Sydney Football Stadium – Precinct Village and Car Park Project (SSD 9835 MOD 7)

Response to Submissions | Transport Assessment

Figure 2 Traffic modelling results – Thursday PM peak hour

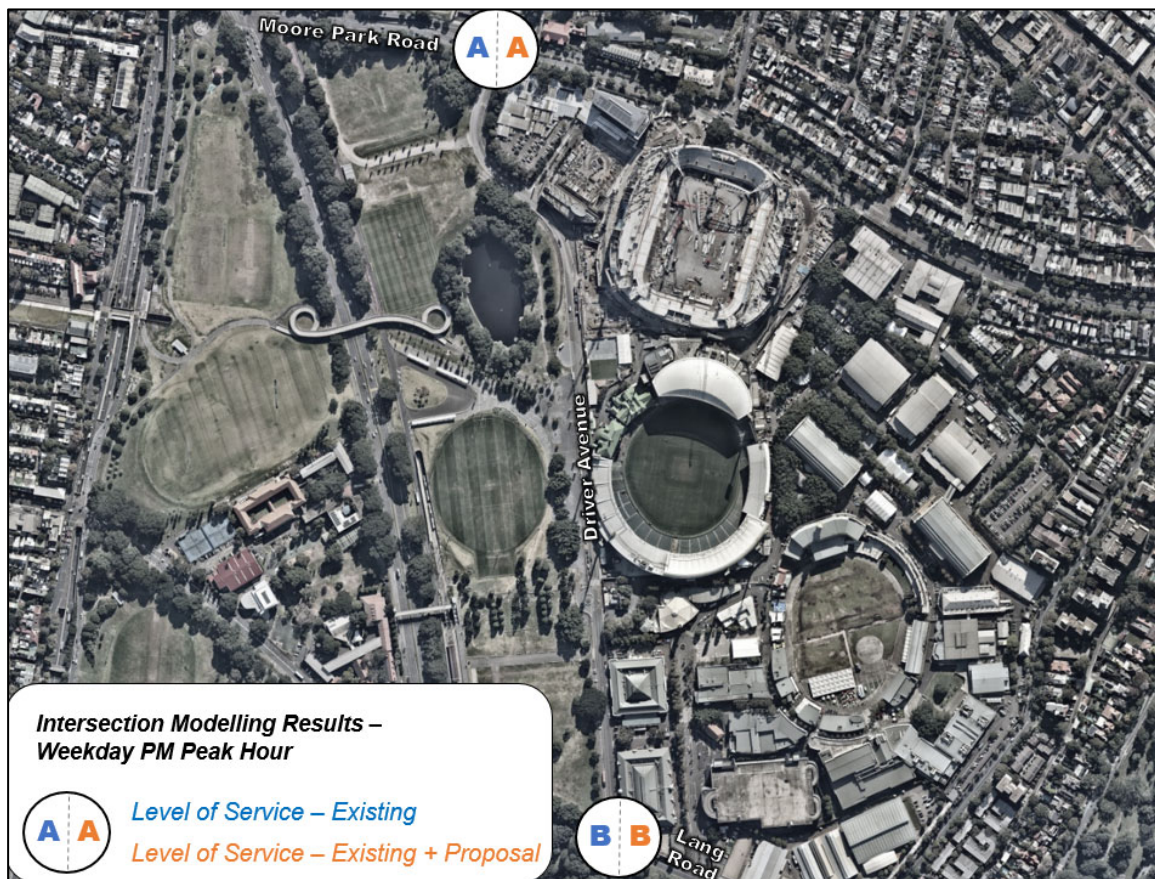
Council's submission raised concern in relation to increased traffic movements associated with the increase in car parking outside of events held at the SFS. Council has recommended that updated modelling should be provided which takes into consideration a scenario where the car park is either filled or emptied (50% of the capacity per hour) during a peak weekday PM peak, and a Saturday lunchtime peak.

These modelling results are summarised in the figures on the following page which further indicate no change in the overall level of service at the two closest intersections to the site.

Figure 5 SIDRA intersection layout showing merge required for eastbound traffic

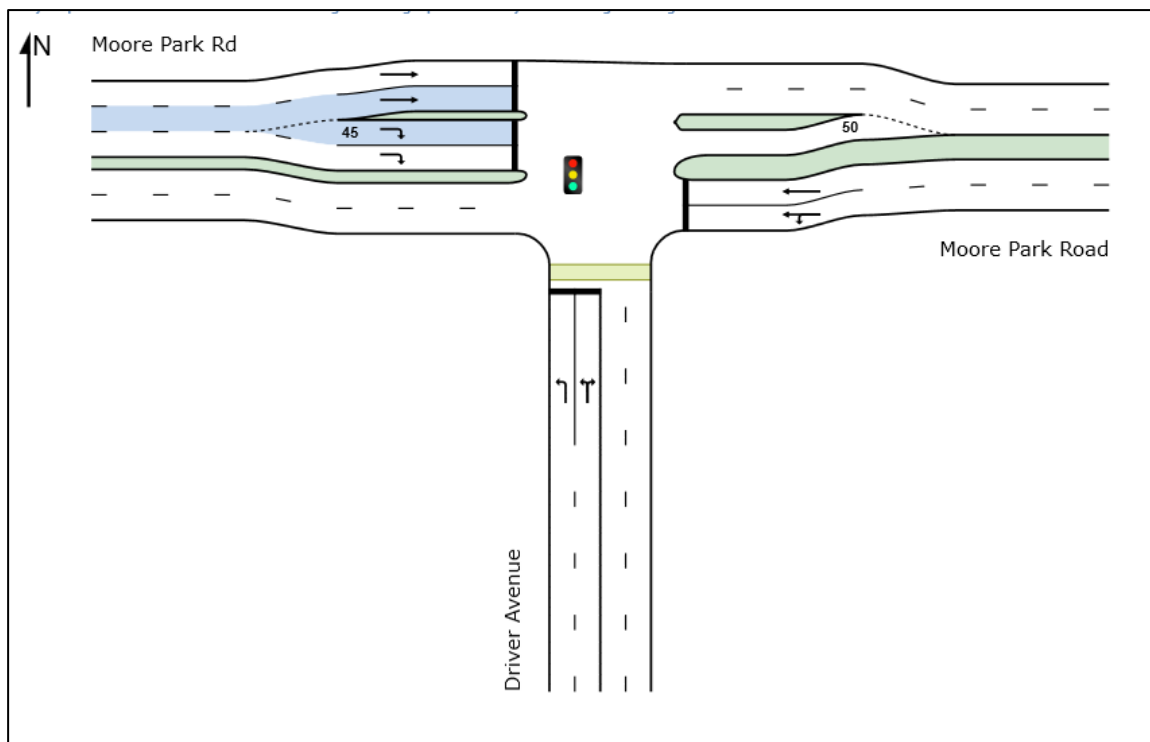
Council also raised the following concern in its submission *“It appears the signalised intersection has been modelled in isolation rather than modelling two sites including the traffic signals and the merge of the right turn into general traffic eastbound on Moore Park Road and connected as a network. If this modelling is incorrect, and it appears to be, consideration must be made to limiting the number of spaces available outside of stadium events.”*

The traffic modelling approach and assumptions utilised in the exhibited Transport Assessment for the Precinct Village and Car Park project have been consistent with those utilised in the Stage 1 and 2 SSD DAs as well as relevant modification proposals (e.g. the Stadium Fitness Facilities). In each of these assessments the required merge for eastbound traffic on Moore Park Road has been considered in the modelling, with the modelled layout presented in Figure 5. Venues NSW provided this SIDRA traffic model to TfNSW for review during the exhibition period of the Precinct Village and Car Park project, with TfNSW confirming as part of its review that the proposed modification will have a negligible impact on the surrounding state road network and TfNSW infrastructure. Therefore, as separately confirmed by TfNSW, the modelling undertaken to support the proposal is considered suitable.
